**INSTALLATION**

The 4807 Switch is no longer available and has been replaced with the 8005 Switch.

Figure 1.

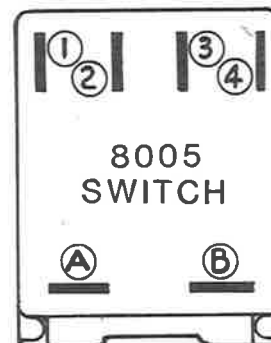
1. Move the wire connections from the 4807 Switch to the 8005 Switch as shown in the hook-up chart in Figure 1.

Remove "L" Terminal Wire	→	Hook up to "A" Terminal
Remove "1" Terminal Wire	→	Hook up to "2" Terminal
Remove "2" Terminal Wire	→	Hook up to "3" Terminal
Remove "3" Terminal Wire	→	Hook up to "1" Terminal
Remove "4" Terminal Wire	→	Hook up to "4" Terminal

2. Remove the 4807 Switch from the mounting panel. (For poultry trainer applications the locating tab must be removed from the mounting hole.)
3. Turn the shaft on the 8005 Switch to the farthest counter-clockwise position and mount in the panel so that the adjustment knob points to "OPEN" on the Static Monitor, or "OFF" on the Poultry Trainer.
